Product Change Notification

Overview: Please be advised that the following is notice of change to Fire Research Focus and Optimum model 200 recessed mount lampheads.

DIMENSIONS ARE IN INCHES		DRAWN: Paul G	DATE: 6/2/2010	TITLE: Focus and Optimum Flushmnt Cutouts	
COMMENTS:				SIZE: A	DWG. NO. PCN1006-01
TOLERANCES:		MATERIAL:		SCALE: 1:3	
ANGULAR: MACH ± .1		FINISH:		FRC	SHEET: 1 OF 1
2 PLACE DECIMAL ± .015					REV:
3 PLACE DECIMAL ± .005

NOTE:
FOR ALL
FOCUS
AND
OPTIMUM
M SERIES
(D30 AND
R90)

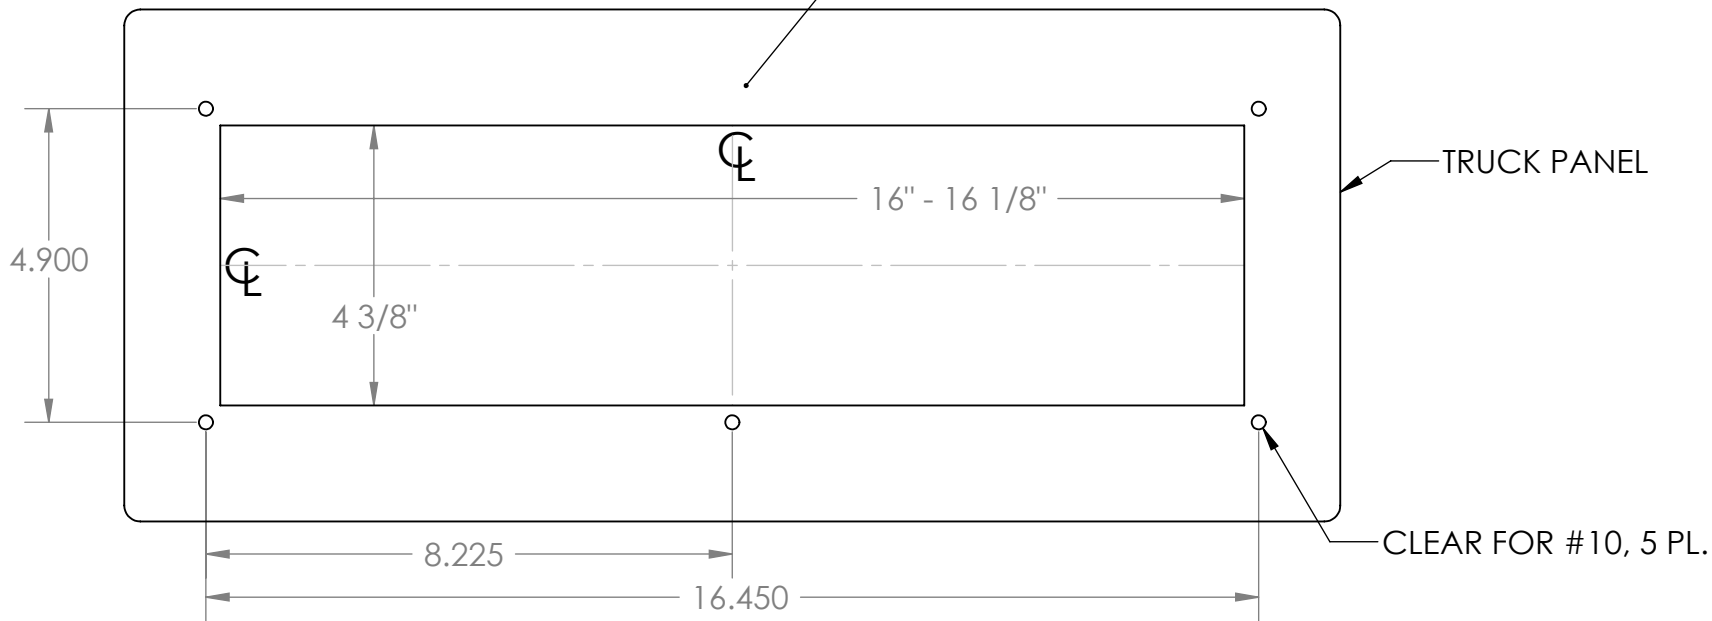
Change Description: The top, center mounting screw for this recessed fixture is being eliminated. There will no longer be a hole in the casting at this position.

TOP MOUNTING HOLE HAS BEEN REMOVED

Replacement Product: The fixture has the same form, fit, and function and will be a direct replacement minus the top center screw. The existing screw hole in the apparatus should be sealed.

NOTE:
FOR ALL
FOCUS
AND
OPTIMUM
S SERIES
(H30 AND
D15)

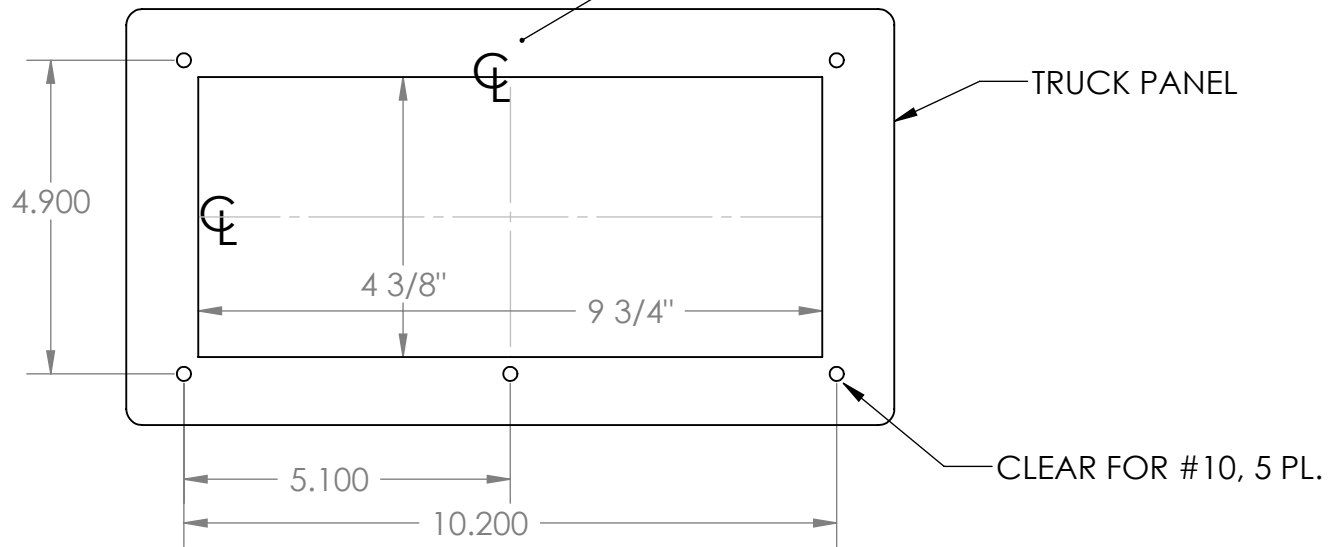
TOP MOUNTING HOLE HAS BEEN REMOVED
